Waterford Place Site Plan Amendment No.1

WATERFORD PLACE SUBDIVISION FILING NO. 2 AND WATERFORD PLACE SUBDIVISION FILING NO. 2, AMENDMENT NO. 1
SITUATED IN THE NW 1/4 OF SECTION 26, T.4S., R.67W. OF THE 6TH P.M.
CITY OF AURORA, COUNTY OF ARAPAHOE, STATE OF COLORADO

Amendment to Waterford Place
Landscape Plan, SDP.5

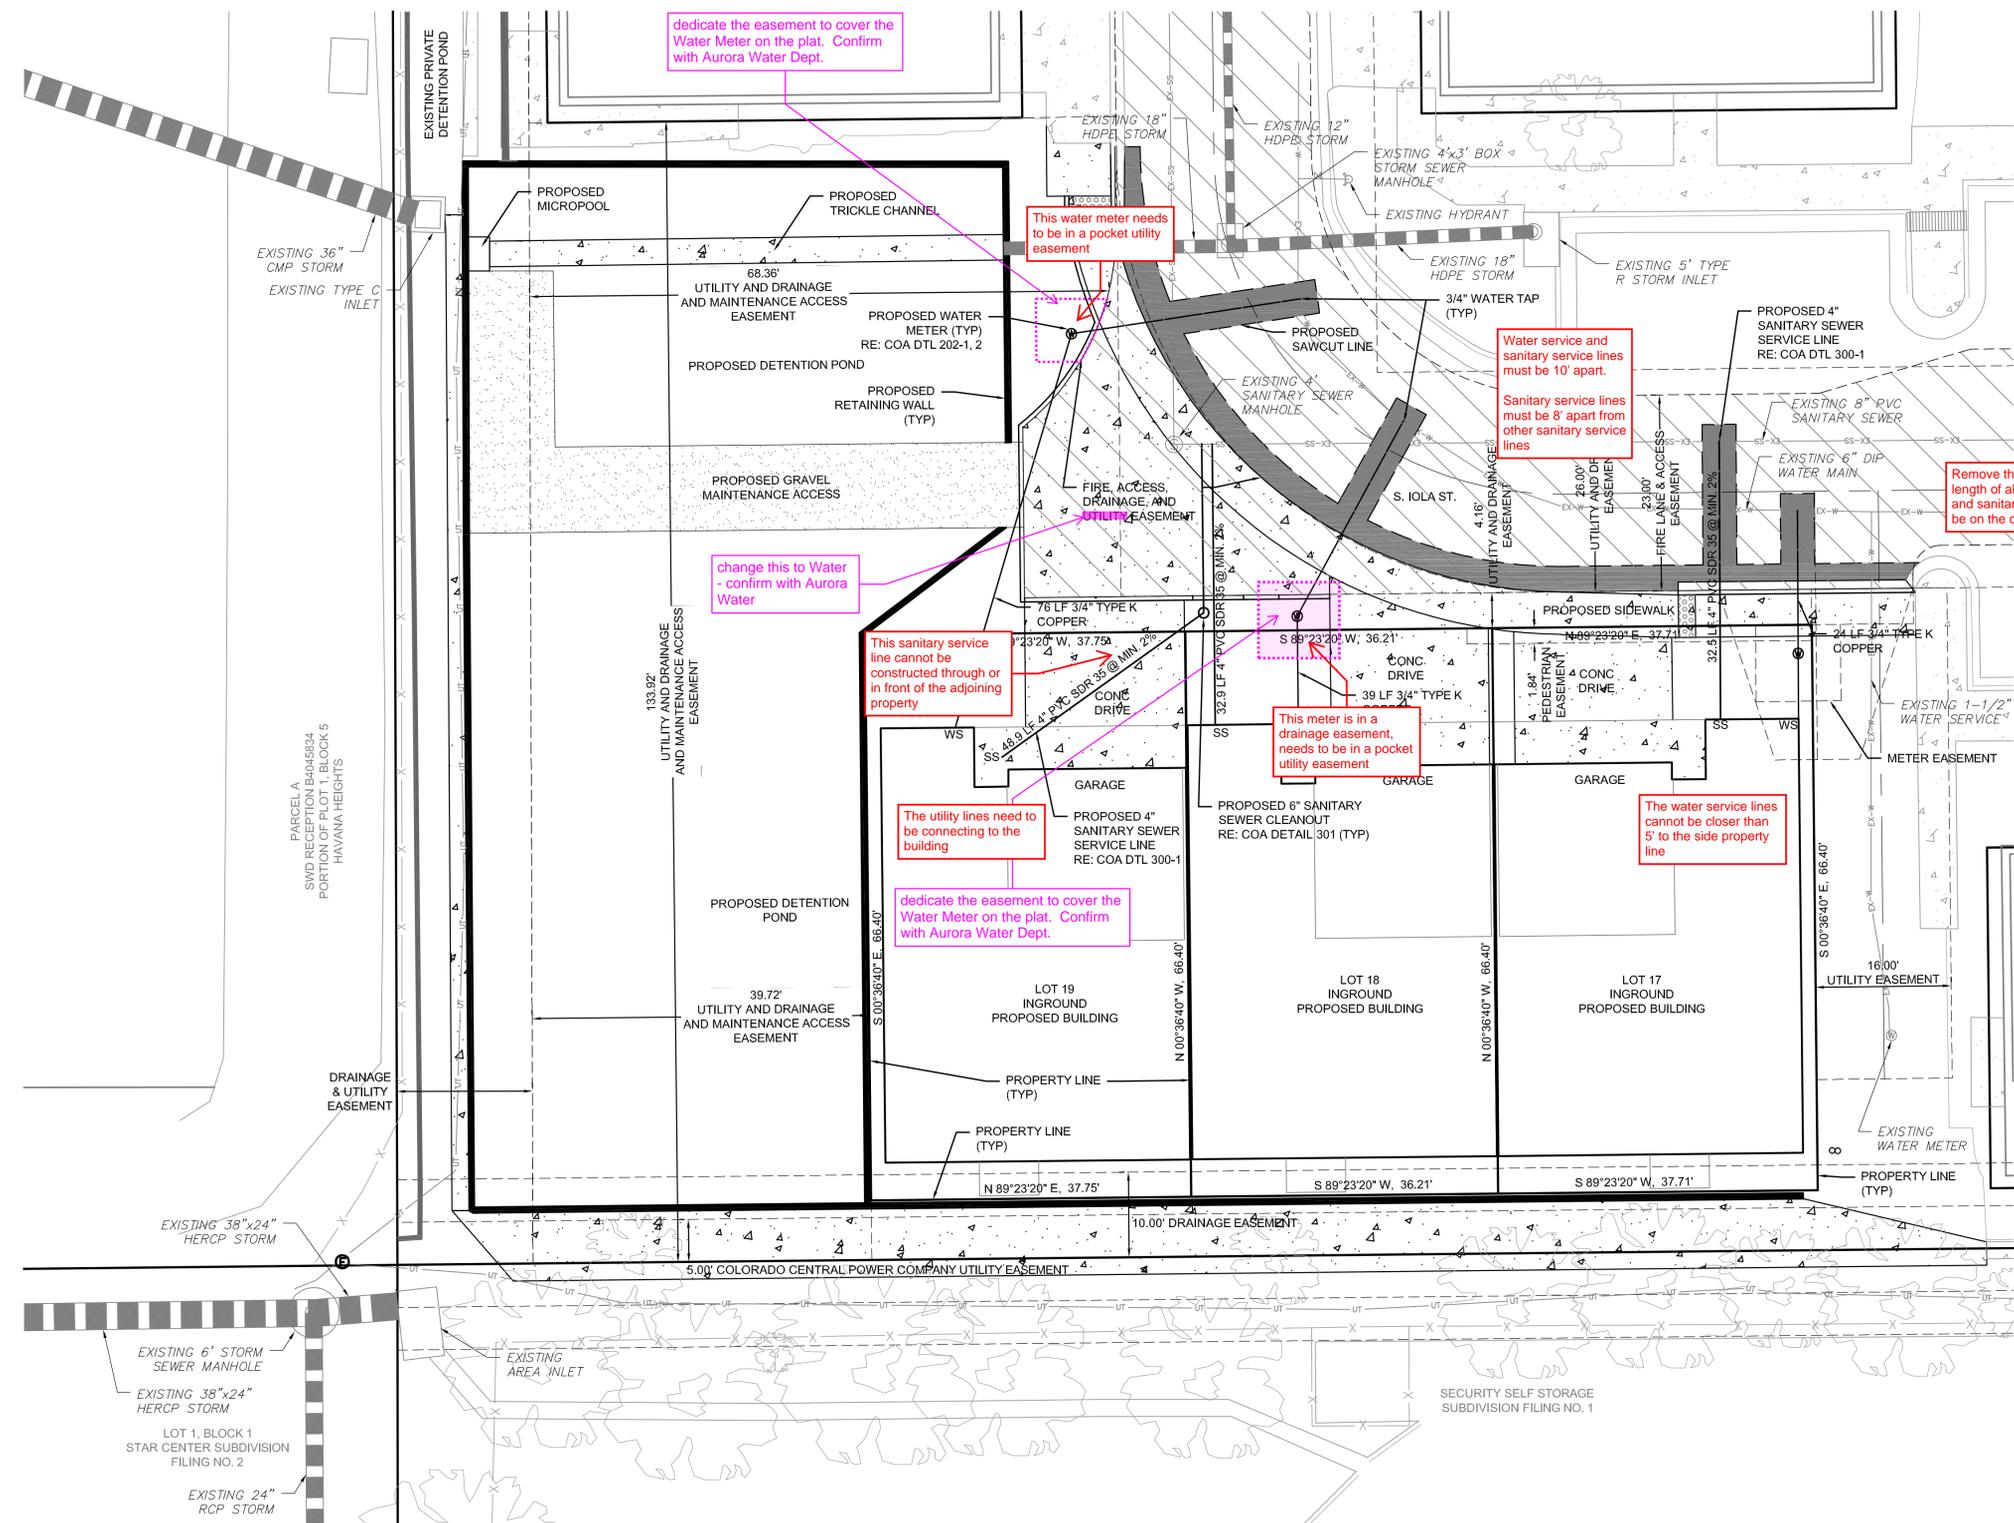
Double check these numbers

Add an asterisk and a note to the bottom of the table stating that an adjustment is being requested for both the southern and western non-street buffers.

What is the vegetative treatment in this area between the existing wall and the proposed concrete pan?

Shrubs need to be 3' away from meters, trees need to be 5' away from meters, and no trees can be within utility easements

Is this a timber wall or concrete wall?

Show the property line as a long dash and two short dashes.

This needs to specifically list the Non Street Buffer Section which is 146-4.7.5.E.

These can be 2.5". Required is 2", upsizing to 2.5" meets the UDO requirements.

Numbers adjusted

Asterisk + note added.

Area is a mulched bed.

Shrubs moved to be 3' from meters. Trees moved to be 5' from meters. Meters indicated in pocket easements.

New wall is concrete per Civil SDP.4, Section B-B

Property Line line type updated as specified.

Text revised

Size changed to 2.5"

1 Front Elevation
Scale: 1/4" = 1'-0"
0 2' 4' 8'

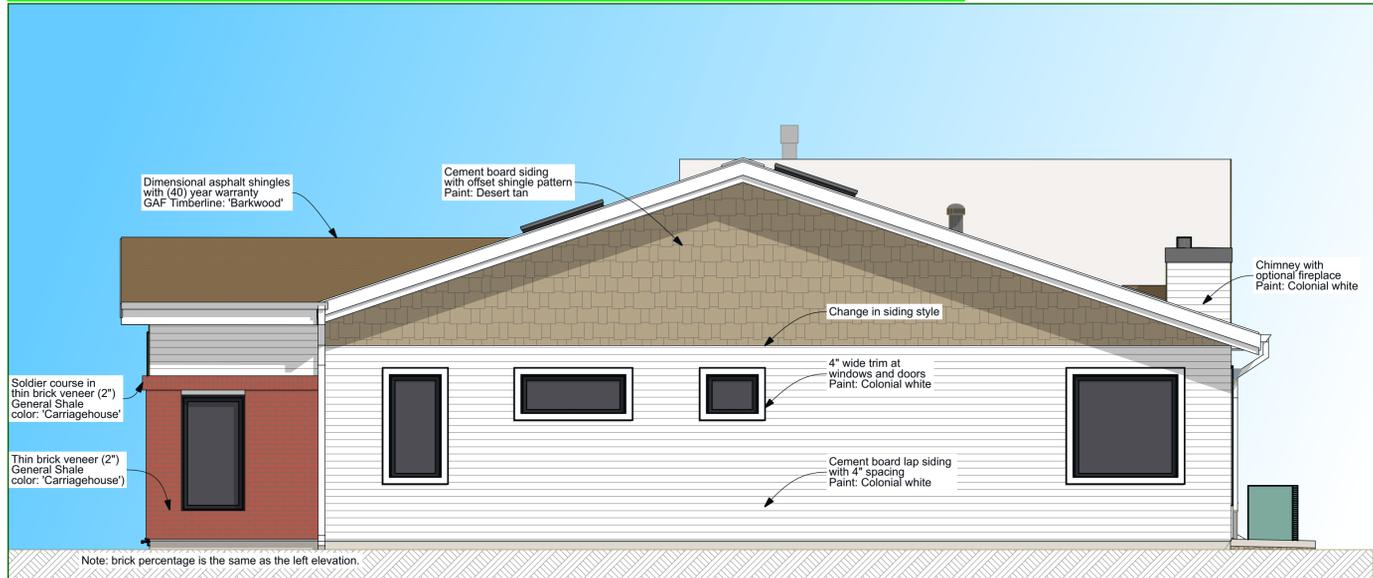
Please adjust your roof -Where sloped roofs are used, at least one of the following elements shall be incorporated into the design for each 60 linear feet of roof to avoid long, flat roof surfaces:
• Projecting gables,
• Hips,
• Horizontal/vertical breaks, or
• Other similar techniques

In a table please provide percentage of masonry shown on the elevations. See Table 4.8-6 for standards for single family attached. (50 percent shall be clad in brick or stone; or 75 percent shall be clad in stucco; or 75 percent shall be clad in a combination of stucco and brick, or stucco and stone.)

Building roof surface was reduced by adding hips to both ends of the building. The resulting ridge is 62'-0"
The cross gable elements on the entry and box bay match the 9' plate height of the primary building.
The brick area on the front elevation was increased and the details adjusted to suit.

Table was added showing areas of brick and percentage brick by elevation.
